MONTGOMERY COUNTY HISTORIC PRESERVATION COMMISSION
STAFF REPORT

Address:	518 Philadelphia Avenue, Takoma Park	Meeting Date:	4/3/2024
Resource:	Non-Contributing Resource Takoma Park Historic District	Report Date:	3/27/2024
Applicant:	Bradley DeGregorio (Richard J. Vitullo, architect)	Public Notice:	3/20/2024
Review:	Historic Area Work Permit	Tax Credit:	No
		Staff:	Chris Berger
Permit Number: 1059042

PROPOSAL: Partial demolition, building addition, fenestration alteration, deck construction.

Figure 9: The proposed rear elevation.

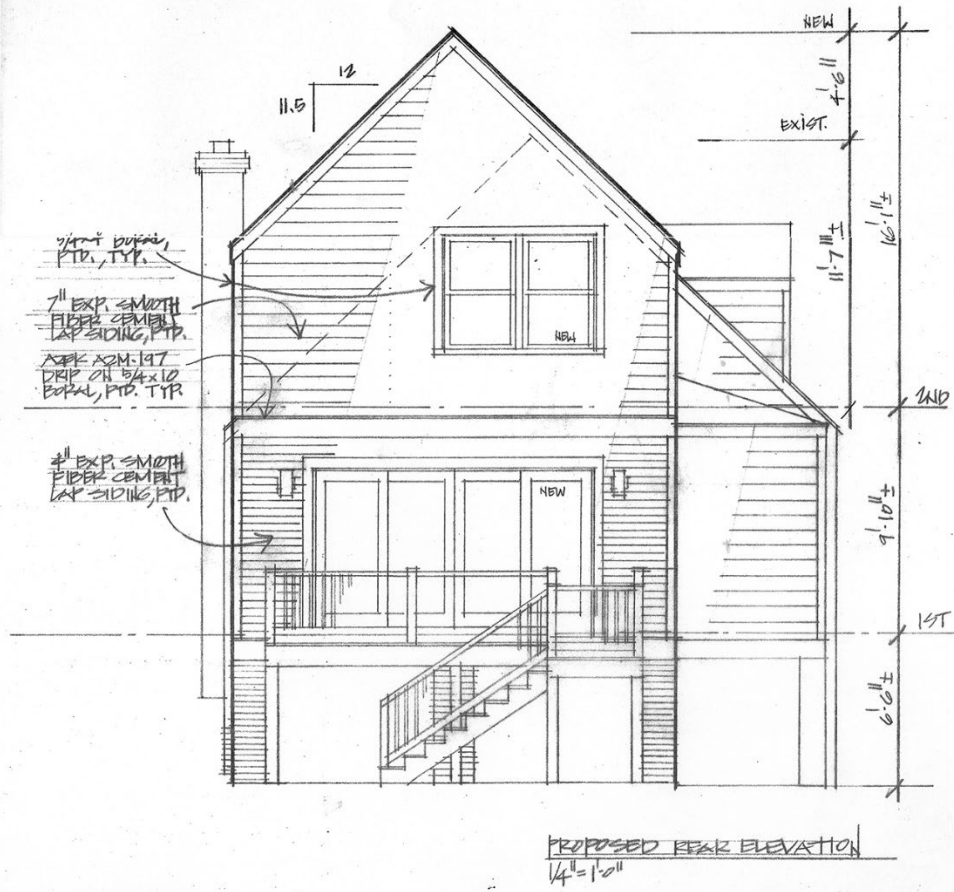
Brick piers will support the walls, covered in smooth fiber cement lap siding. The fiber cement lap siding is a compatible material for the building, which has lap siding in the upper gables. The applicant was unable to match the 8-inch lap siding reveal on the existing residence, but the 7-inch siding on the second floor of the addition will be a close approximation and was supported by the HPC at the preliminary consultation. The first floor of the addition will have 4-inch lap siding. The gable roof pitch will be 11.5/12 inches to match the pitch of the two existing gable roofs. The roof will be covered with architectural-grade asphalt shingles. (Staff seeks a condition that a roof plan is provided.) An octagon-shaped vent is proposed for the gable peak of the new gable roof to match the existing roof vents at the gable ends; the materials of the proposed vent are unknown. The aluminum-clad wood windows will be 6/1 and 1/1 double hung sash; 1/1 light sliding; and one-lite casement. A window was added to the right-side elevation in response to HPC's direction. On the rear elevation four doors will be installed to the proposed deck. The window, door, and corner trim will be painted Boral, and the window sills will be Azek. An 80-square-foot pressure-treated wood deck with stairs will be built to the rear of the new addition.

According to the *Guidelines*, additions to Non-Contributing Resources such as the subject property should be approved as a matter of course with the exception of major alterations that affect the surrounding streetscape and/or landscape and could impair the character of the historic district. Similarly, Chapter 24A-8(d) states that the HPC "shall be lenient in its judgment of plans for structures of little historical or design significance or for plans involving new construction, unless such plans would seriously impair the historic or architectural value of surrounding historic resources or would impair the character of the historic district." Staff supports the design of the proposed addition and the proposed materials. Though it will be one story taller than the existing house, it will be located on the downslope. The addition will be located on the rear elevation, and it will not impair the character of the historic district. The proposed gable roof's placement and slope harmoniously matches the existing roof pitches when viewed from the right of way. Further, the addition meets Chapter 24-8A(b)(1), because the proposal will not substantially alter the exterior features of an historic resource within an historic district, and Chapter 24-8A(b)(2) because the addition is compatible in the character of the historic district. In accordance with the applicable Standards, the historic character of the property will be retained and preserved by the addition; the exterior alteration will not destroy historic materials that character a property; and the integrity of the historic property and environment will be unimpaired if the addition is removed.

Figure 10: The proposed right-side elevation.

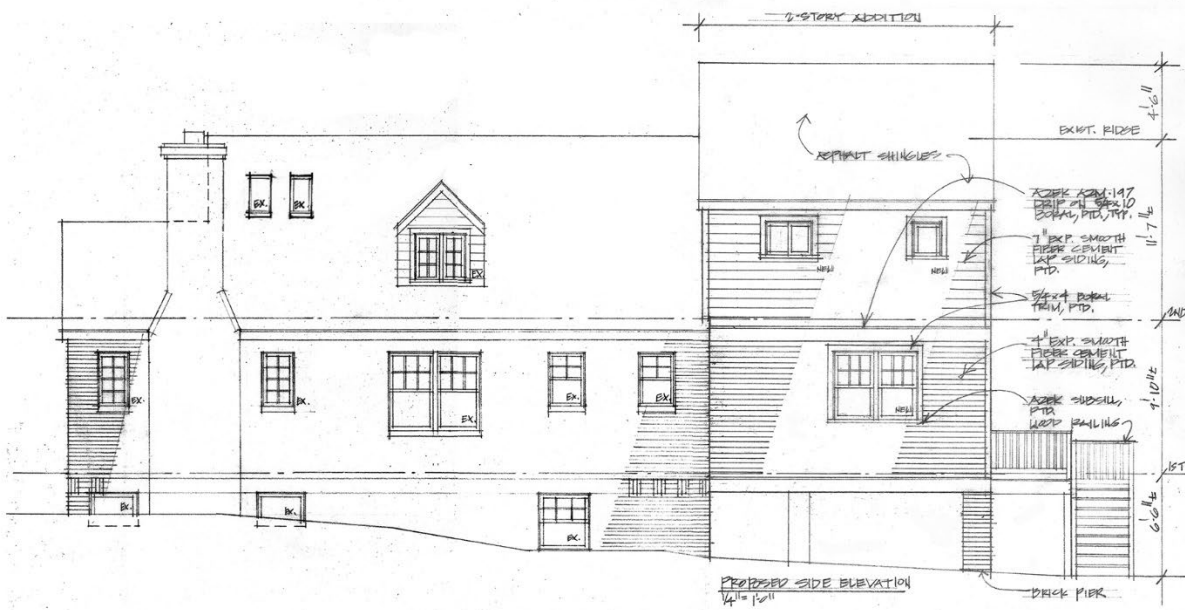
Commissioners requested a 3-D rendering of the proposed rear addition to show the building’s massing and a faux window to break up the massing on the right-side elevation.

- The front porch will no longer be enclosed.
- The height of the addition was reduced 6 inches.
- An awning window measuring 2-feet-by-1-foot, 9-inches, was added to the second floor on the

right-side elevation.

Figure 12: This streetscape shows how the addition will be scaled to the residences along Philadelphia Avenue.

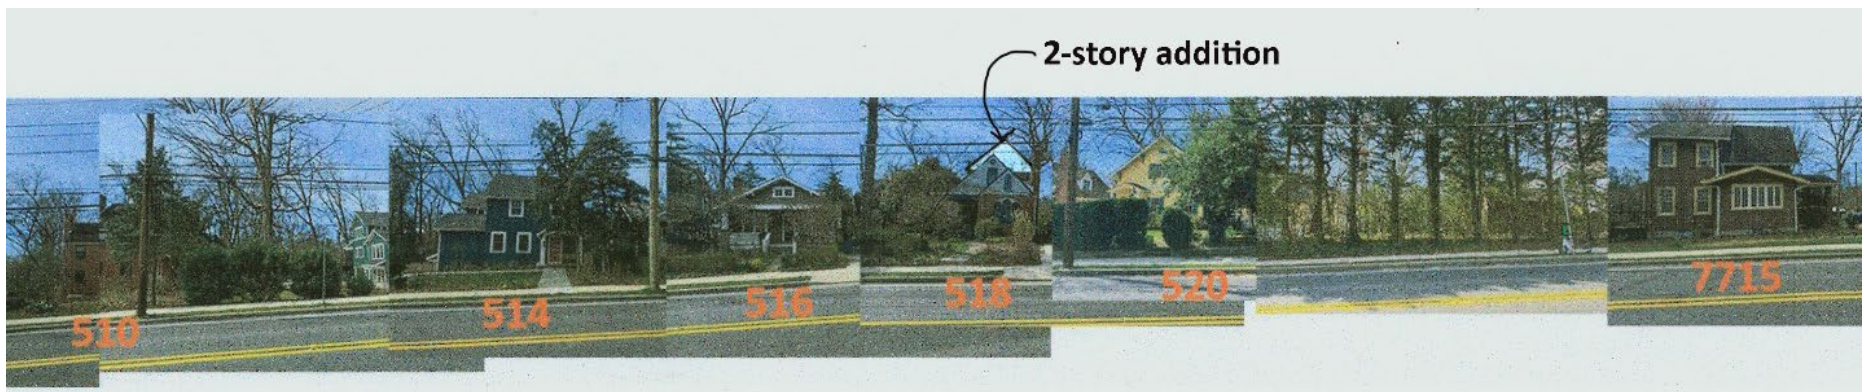
The streetscape showing the addition in relation to the facades of the other homes on the block is helpful, but we believe HPC is seeking additional views to better understand the massing of the addition from the sides.

Your perspective drawing of the front and right-side elevation is on the right track; just step back the view to include the adjacent houses at 516 and 520 Philadelphia. Then do the same with the left-side elevation.

The attached PDF is the only view that really effectively shows the addition in relation to the adjacent houses. The view from the left would be frankly difficult to generate and isn't nearly as helpful as the view from the right side.

Figure 13: The existing window, left, will be replaced and two casement windows will be installed to either side of it.

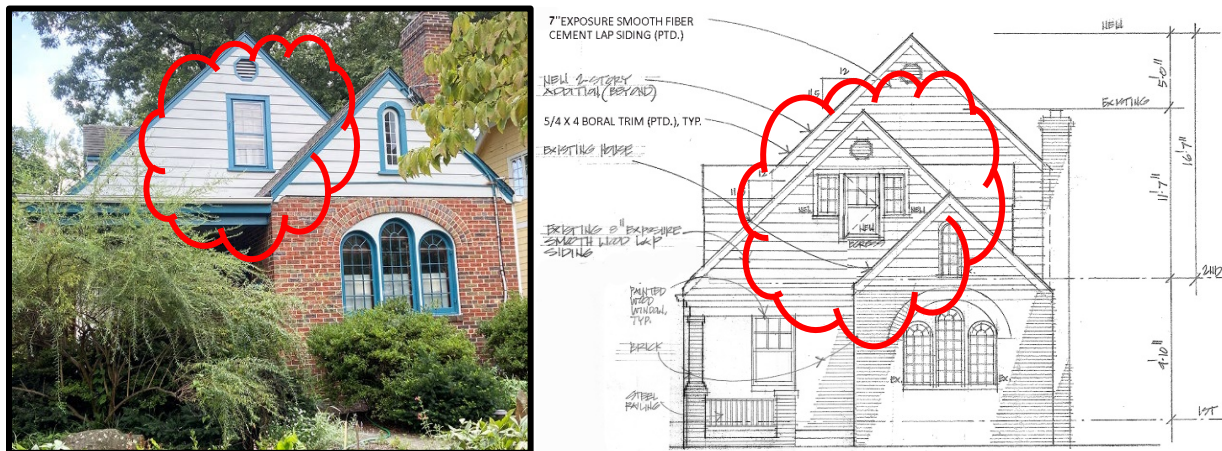
The existing 6/6 sash window on the front elevation will be replaced with a 6/1 wood casement egress window. Six-lite aluminum-clad wood casements will be installed to either side of the 6/1 (*Figure 13*). The larger window will serve as egress for the bedroom. Staff recommends that the muntins of the windows are either true-divided lite or simulated divided lite with permanent exterior and interior grilles.

2. The applicant shall contact the City of Takoma Park Urban Forester; follow all recommendations and requirements; and forward the correspondence to staff.
3. The applicant shall provide a roof plan prior to final approval of the HAWP.
4. The aluminum clad window grilles shall be either full divided lite or simulated divided lite with permanent exterior and interior grilles.
